# UNITED STATES PATENT AND TRADEMARK OFFICE

APPLICATION NO.	FILING DATE	FIRST NAMED INVENTOR	ATTORNEY DOCKET NO.	CONFIRMATION NO.
09/660,209	09/12/2000	Charles W. Mitchell	1001-0135	6900
22120	7590	05/05/2005	EXAMINER	
ZAGORIN O'BRIEN GRAHAM LLP 7600B N. CAPITAL OF TEXAS HWY. SUITE 350 AUSTIN, TX 78731			LAU, TUNG S	
			ART UNIT	PAPER NUMBER
			2863

## Office Action Summary

## DETAILED ACTION

**FIG. 2**

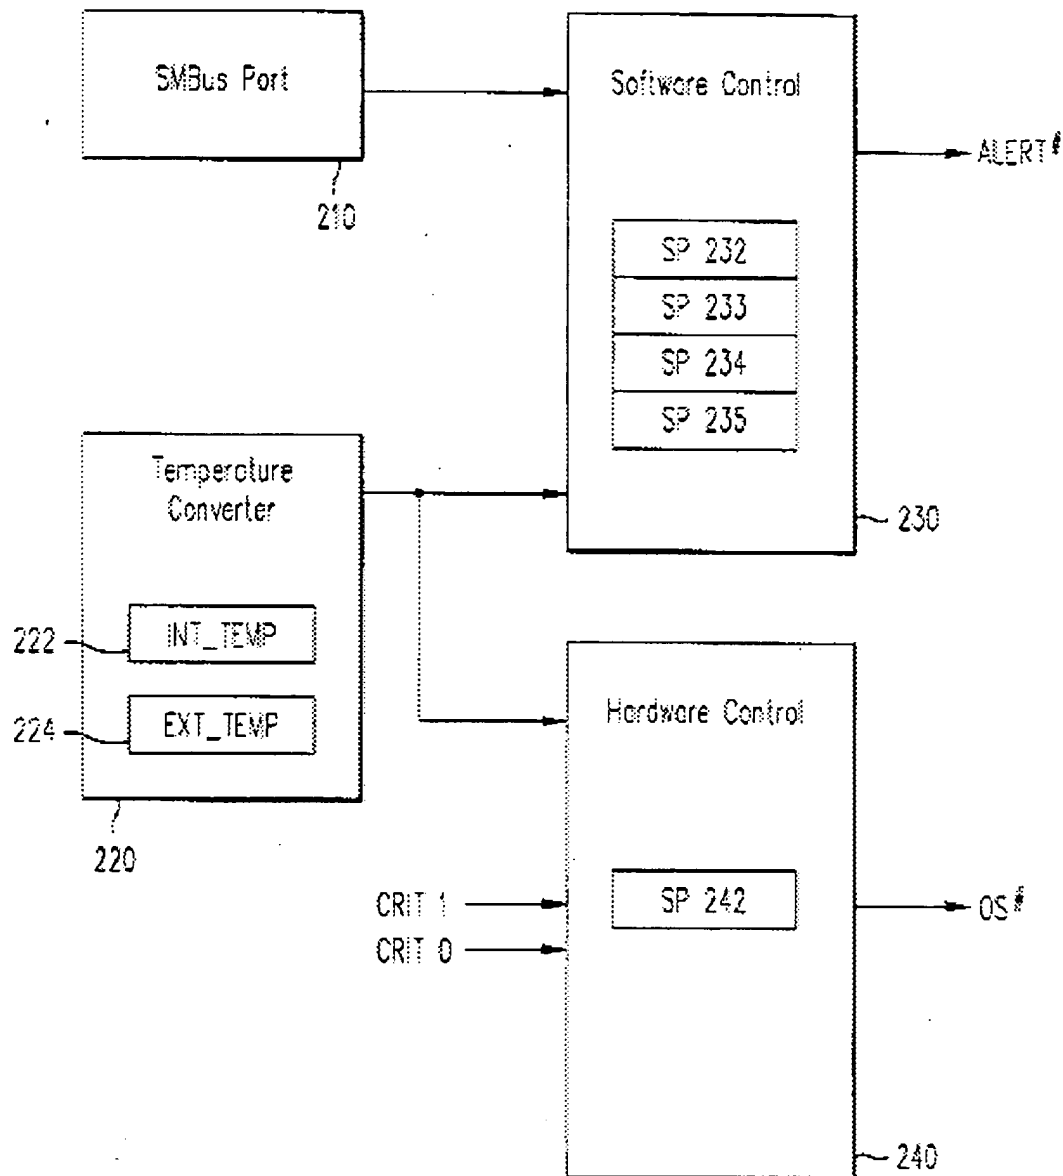
A. Applicant argues in the arguments that the prior art does not show the 'provides accessibility to a programmable storage location'. Hussain clearly discloses 'provides accessibility to a programmable storage location' in Col. 2-3, Lines 40-16, Col. 6, Lines 20-31, where in fig. 2, register 232-235 in block 230 is the 'provides accessibility to a programmable storage location'.

FIG. 3

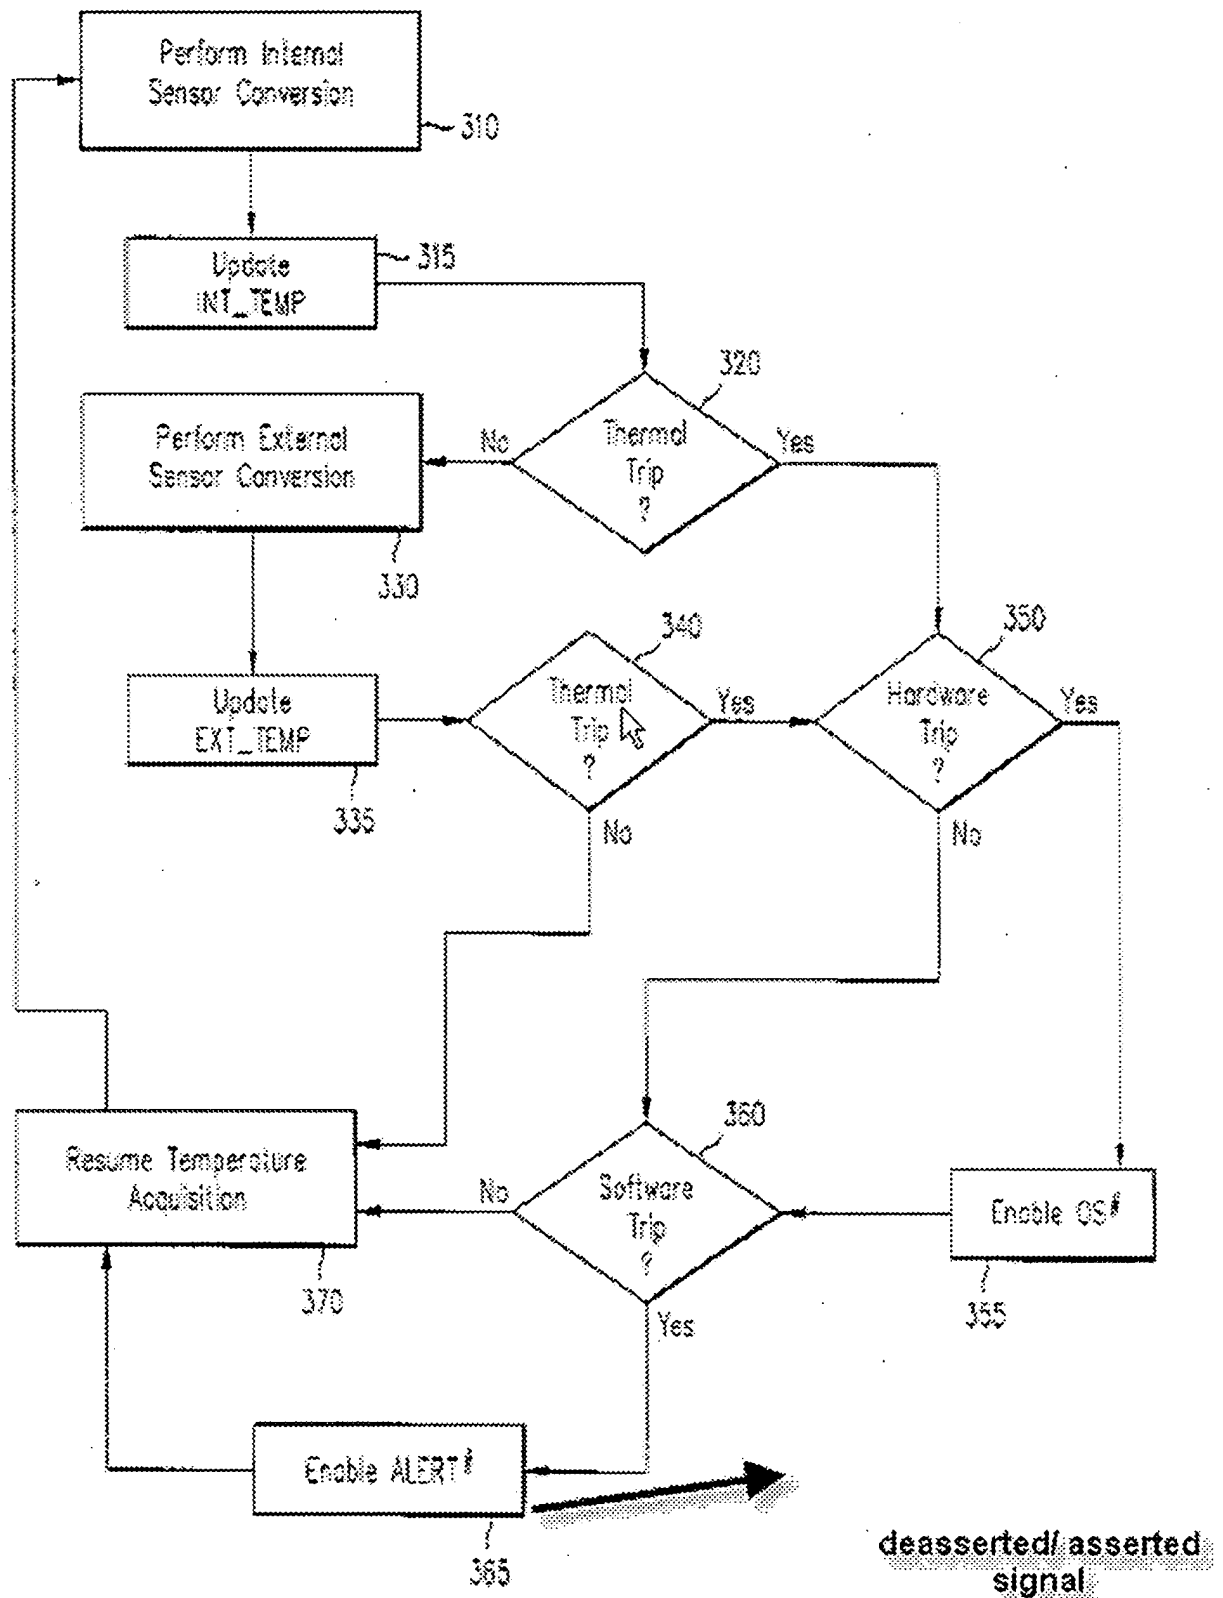
B. Applicant continues to argue in the arguments that the prior art does not show the 'the signal on the first output terminal is deasserted according to a programmable mode of operation that includes deasserting in response to at least one of a control location on the integrated circuit being accessed and the

measured'. . Hussain discloses 'the signal on the first output terminal is deasserted according to a programmable mode of operation that includes deasserting in response to at least one of a control location on the integrated circuit being accessed and the measured' in Col. 2-3, Lines 40-16 and fig. 3, unit 365, fig. 4, unit 440, fig. 5.
